Service Bulletin

No. : MZ09-153

Model: SR8002, SR7002

Subject: Change in the "UL mark" on the rear panel because the expiration date of the "safe standard of Canada (CSA)" expired.

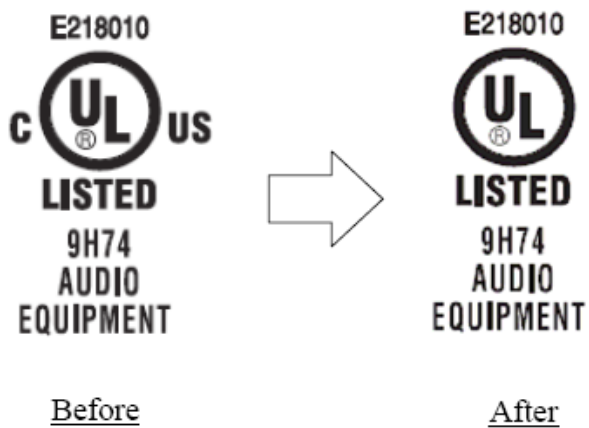
Details: The listed models were authorized under "UL1492" and "CSA22.2 No. 1-04". However, the expiration date of "CSA22.2 No. 1-04" expired at 31st of December 2009. Therefore, we changed the "UL mark" on the rear panel from "a mark for both of UL and CSA" to "a new mark for UL only".

We will apply the above modification to models in the following serial numbers.
(Full-digit)

Model	Serial Number
SR8002	MZ111004005351 ~
SR7002	MZ111002009691 ~
